Plumbing Permit Set - Equipment Replacement Puyallup School District Central Kitchen Facility

CENTRAL KITCHEN FACILITY
3607 17th St SW Puyallup, Washington
SHEET TITLE
**MECHANICAL/ELECTRICAL
SITE PLAN**

SHEET NO.
ME1.0
PROJECT NO.
7351

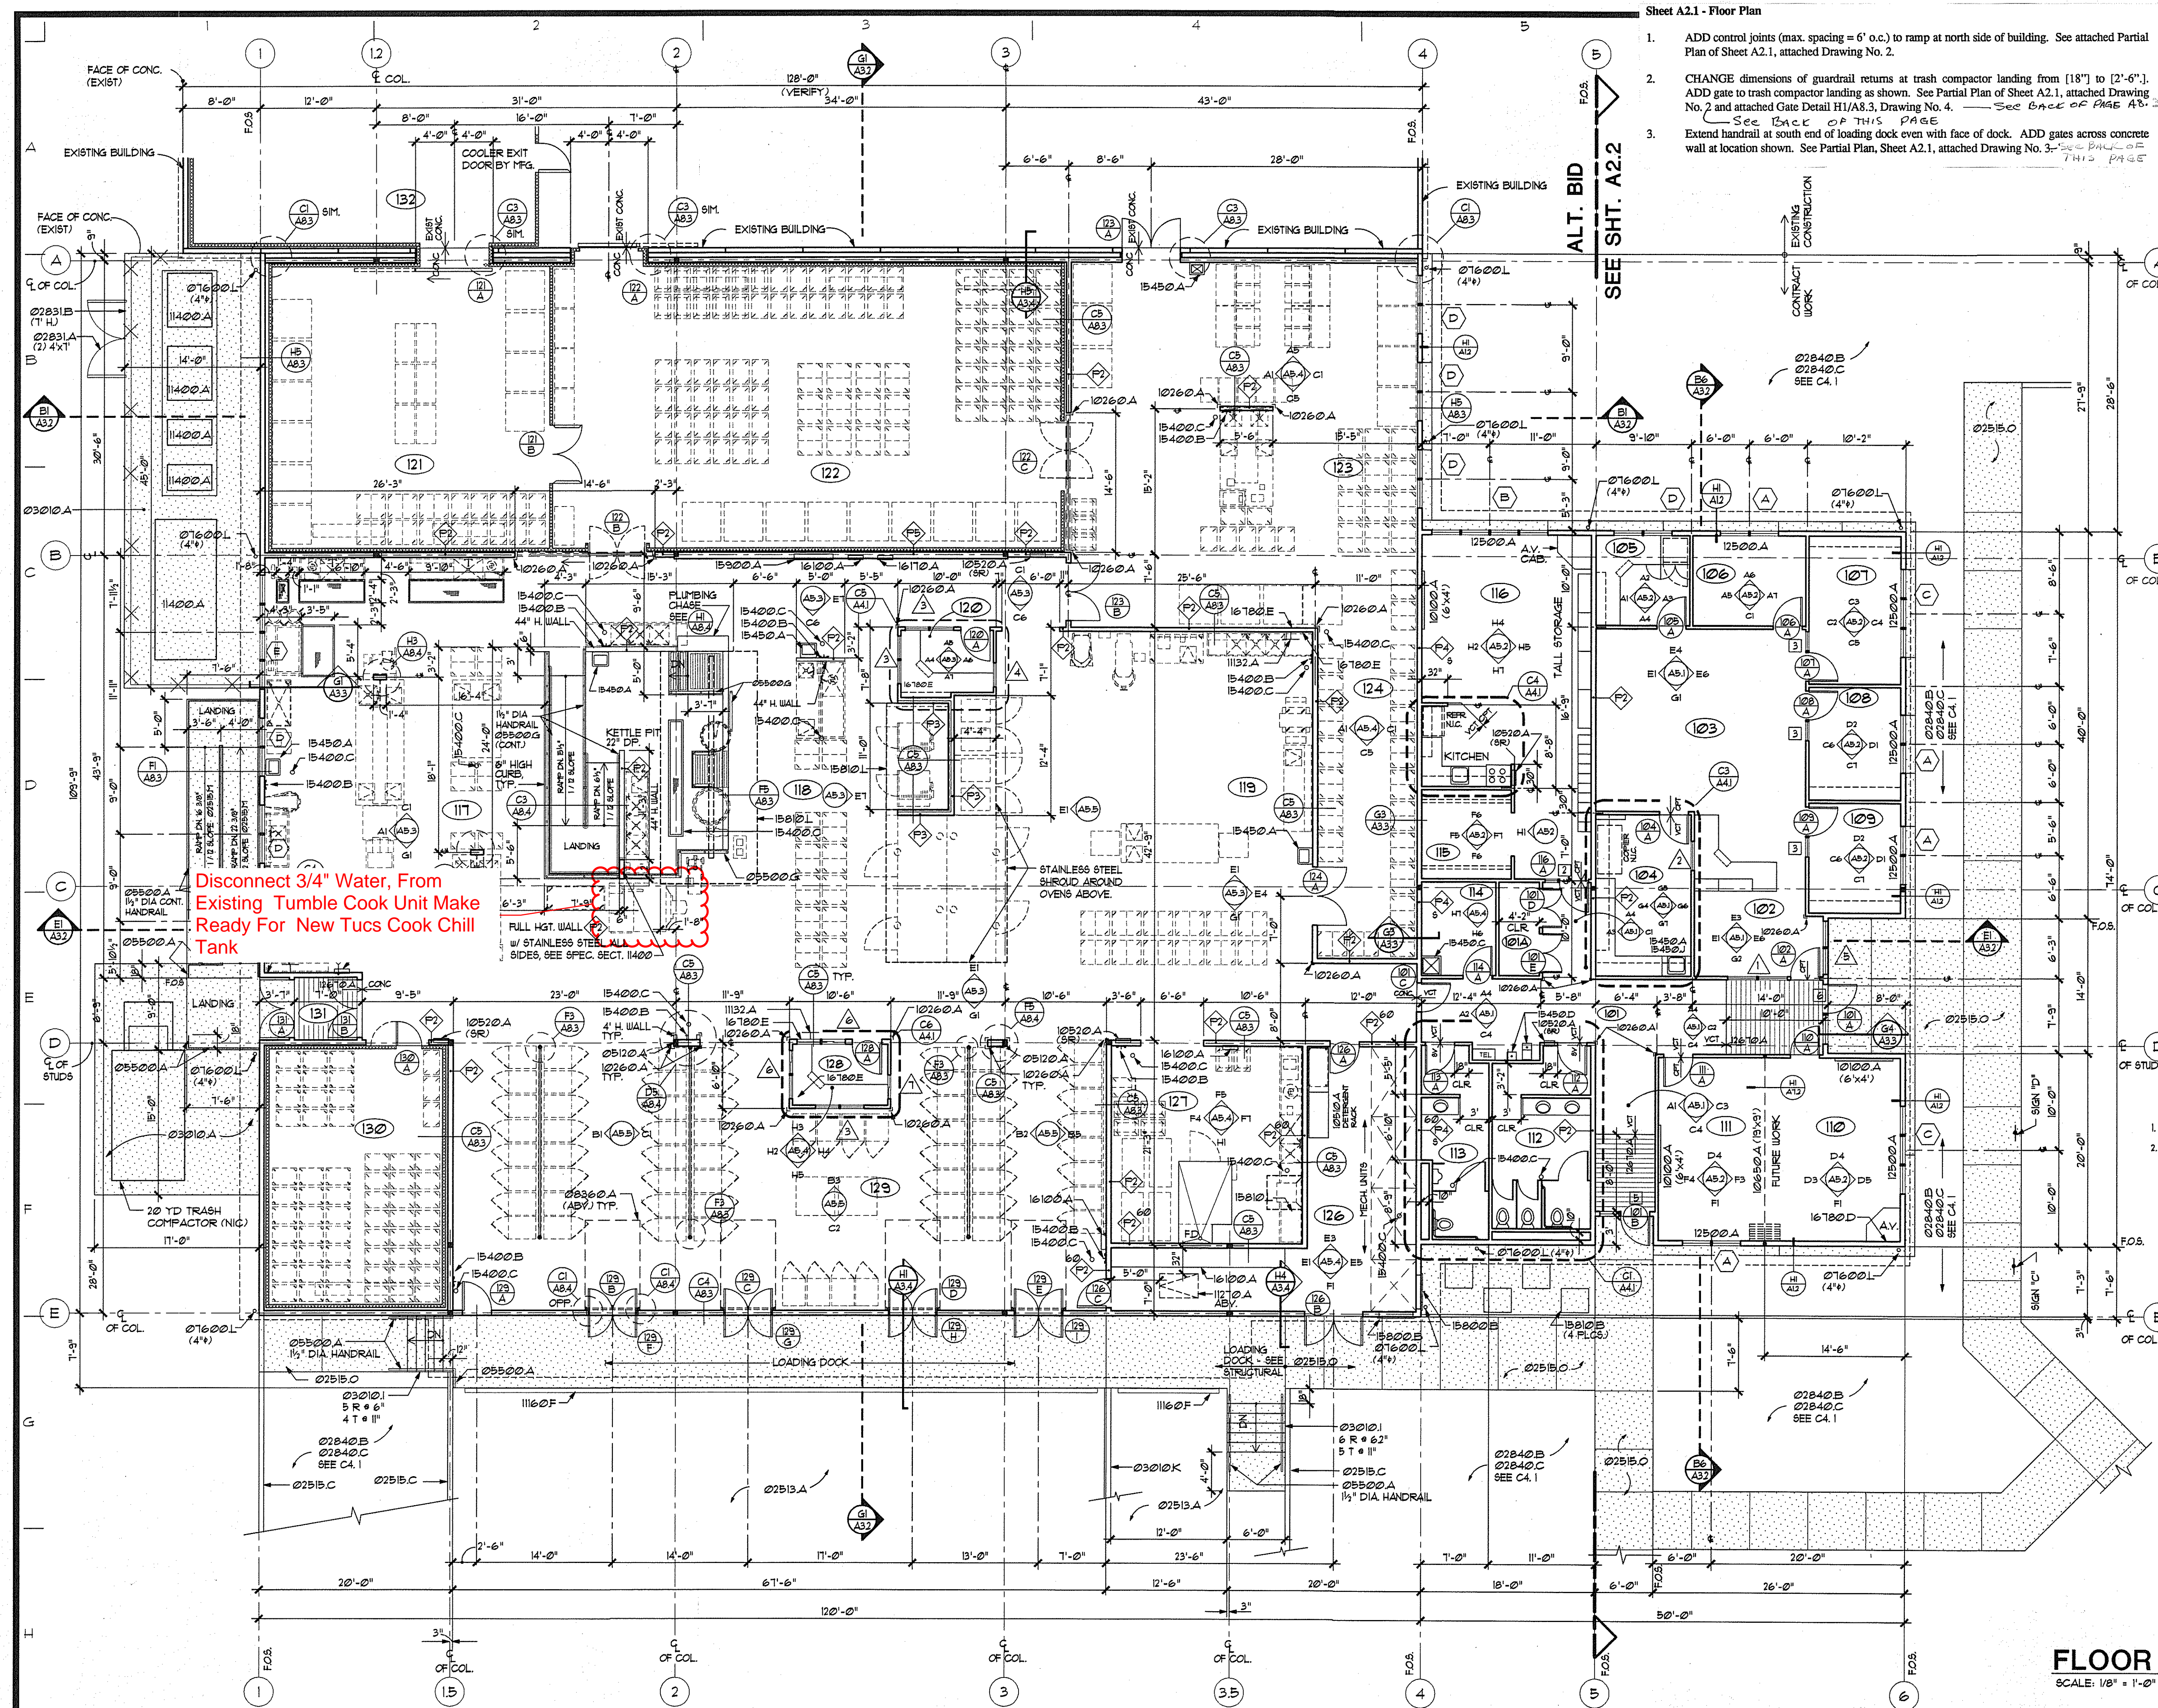
1. Sheet ME1.0: Refer to attached sketch SK/ME1.0 dated April 16, 1996.

- Provide 3/4 inch underground conduit with (4) #14 conductors from vault provided by water Co. to the new fire alarm control panel located in room 114 (Sheet E2.1). Connect valve tamper switches in vault to fire alarm control panel.
- Provide 3/4 inch underground conduit with (3) #12 conductors from vault to PNL-A Circuit 15. Provide outlet and manual starter in pit and connect to sump pump.
- Note location of existing P.I. valve. Provide 3/4 inch underground conduit with (4) #14 conductors from valve to fire alarm panel. Existing conduit and wire to existing fire alarm control panel may be reused, if suitable.

8. Sheet ME1.0

- Relocate water meter and CW building service to new location per partial Site Plan attached sketch SK/ME1.0.

SHEET NO.:
A2.1

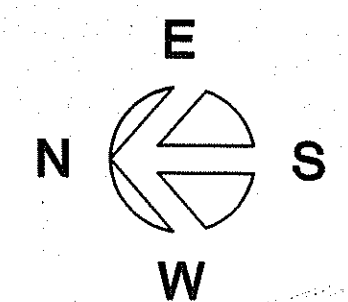
- Sheet A2.1 - Floor Plan
- ADD control joints (max. spacing = 6' o.c.) to ramp at north side of building. See attached Partial Plan of Sheet A2.1, attached Drawing No. 2.
 - CHANGE dimensions of guardrail returns at trash compactor landing from [18"] to [2'-6"]. ADD gate to trash compactor landing as shown. See Partial Plan of Sheet A2.1, attached Drawing No. 2 and attached Gate Detail H1/A8.3, Drawing No. 4. See BACK OF THIS PAGE
 - Extend handrail at south end of loading dock even with face of dock. ADD gates across concrete wall at location shown. See Partial Plan, Sheet A2.1, attached Drawing No. 3. See BACK OF THIS PAGE

KITCHEN PLUMBING PLAN B

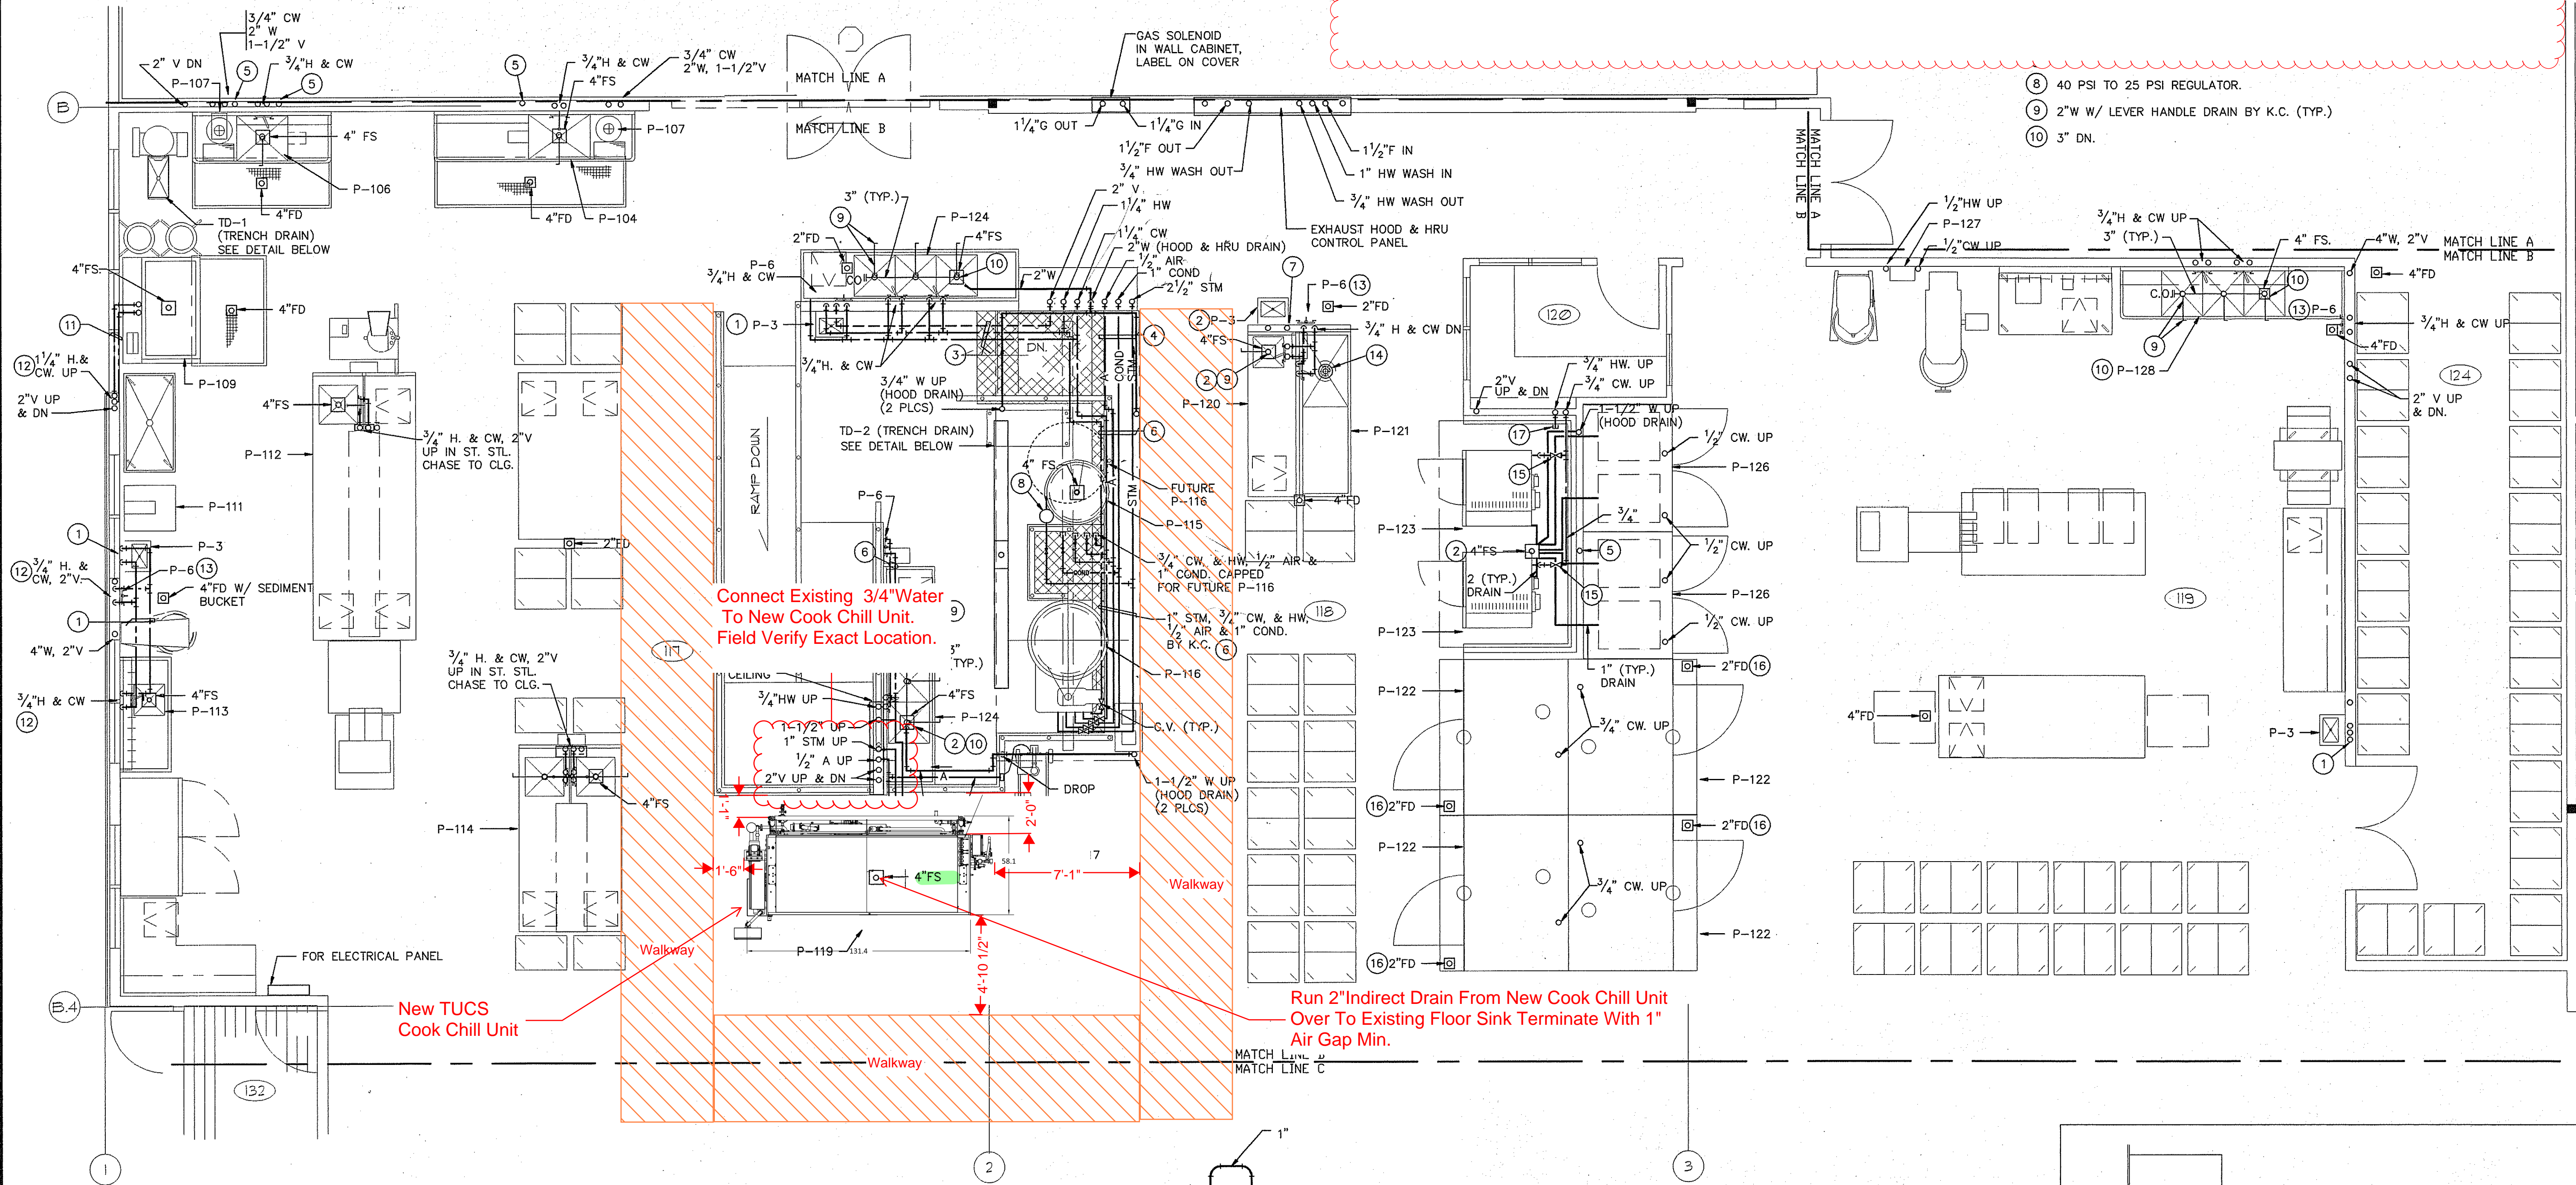
- Disconnect existing water, and drain from existing Chiller Tumbler
- Connect water and run drain line to floor sink for new cook chill tank unit
